Technical Bulletin 184 02.2018

Contents

1. Final drive belt

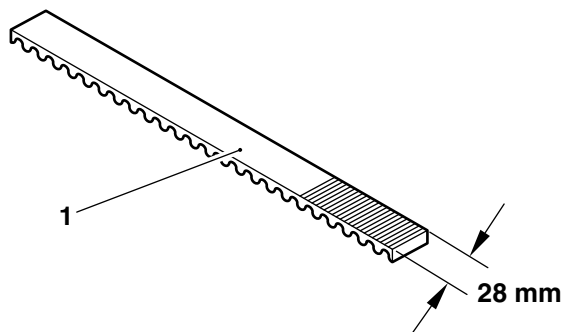
Measure the width of the final drive belt. If the width of the final drive belt is 28 mm or less, the drive belt must be replaced.

1. Reflector
2. Front mudguard mounting

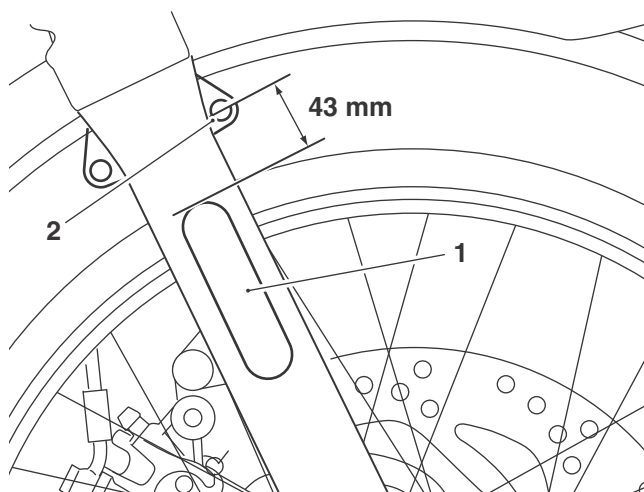
- **When fitting a new reflector to the front fork, it must be fitted 43 mm from the centre of the front mudguard mounting holes.**
1. Using a cleaning wipe, clean the area of the front fork prior to fitting the reflector to the front forks.
 2. After allowing the cleaned area to dry naturally, peel the protective film from the back of the reflector.

- **When fitting self-adhesive parts care must be taken to ensure positioning is correct and accurate. Once the adhesive has been attached to the mounting surface, there is no satisfactory method of removal or re-positioning if incorrectly aligned. Initial bonding is instant, full bonding is achieved after 72 hours.**
3. Fit the reflector to the front fork 43 mm below the centre of the front mounting holes, as shown in the illustration below.

1. Reflector
2. Lower edge of the lower yoke

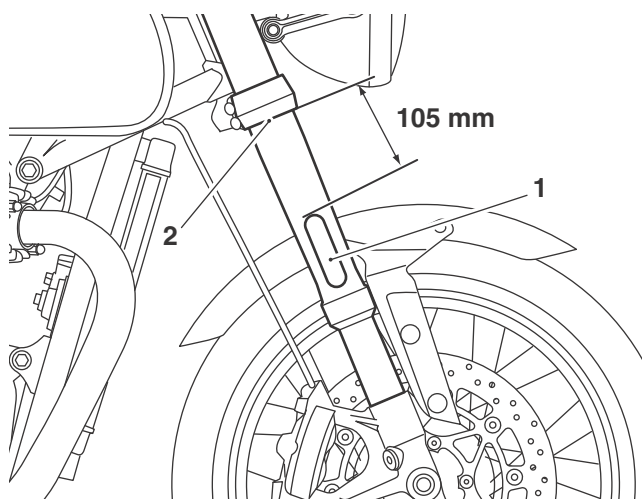
- **When fitting a new reflector to the front fork, it must be fitted 105 mm from the lower edge of the lower yoke.**
1. Using a cleaning wipe, clean the area of the front fork prior to fitting the reflector to the front forks.
 2. After allowing the cleaned area to dry naturally, peel the protective film from the back of the reflector.

- **When fitting self-adhesive parts care must be taken to ensure positioning is correct and accurate. Once the adhesive has been attached to the mounting surface, there is no satisfactory method of removal or re-positioning if incorrectly aligned. Initial bonding is instant, full bonding is achieved after 72 hours.**
3. Fit the reflector to the front fork 105 mm from the lower edge of the lower yoke, as shown in the illustration below.

1. Clutch cable
2. Cable guide clamp
3. Fixing M5 x 10 mm encapsulated
4. Cable guide
5. Rubbing strip
6. Harness guide
7. Fixings M5 x12 mm

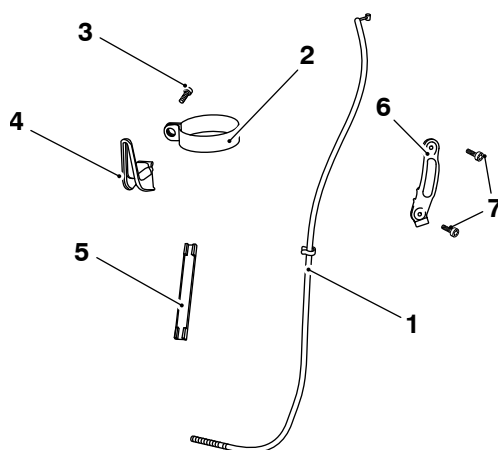
A new clutch cable guide and clutch cable rubbing strip has been introduced to the above models from VIN 863367.

For models up to VIN 863366, Triumph recommends that if the clutch cable requires replacing the cable guide on the left hand fork is to be replaced also. To facilitate this a parts kit (part number T2021648) is available and consists of the following:

- Upper yoke**
- Cable guide clamp**
- Centre line for fork**
- Centre line for cable guide**
- Cable guide**

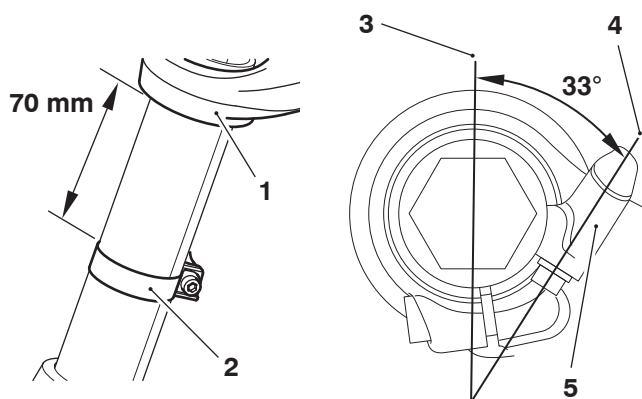
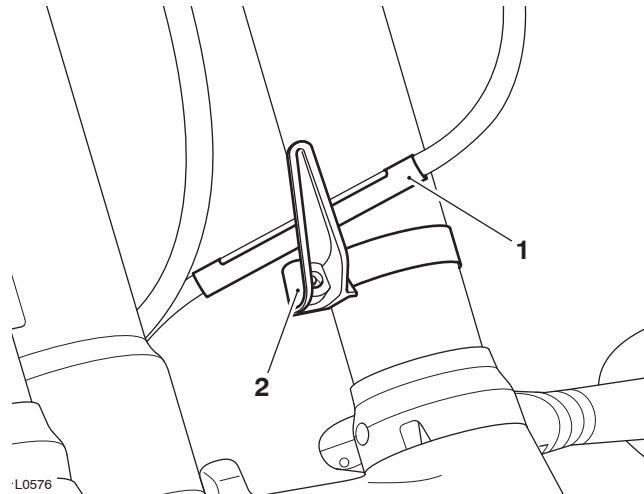
- With the steering in the straight ahead position, the clutch cable guide is to be positioned 33° from the centre line of the fork and the top edge of the clutch cable guide clamp 70 mm from the lower edge of the upper yoke.

- With the clutch cable guide assembly in its correct position, tighten the fixing to **3 Nm**.

1. Identifying mark of new condition detent wheel

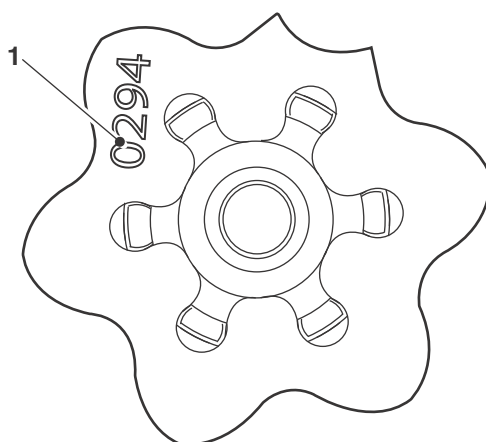
- If replacing the detent lever spring, an original condition part can be ordered unless a new condition detent wheel has already been fitted.
- If replacing the detent wheel with a new condition part, both parts must be replaced. To facilitate this, a parts kit (part number T1190758) is available.

The new detent wheel has a revised profile and is identified by the marking '0294' on the face. The new detent lever spring has increased spring torque.
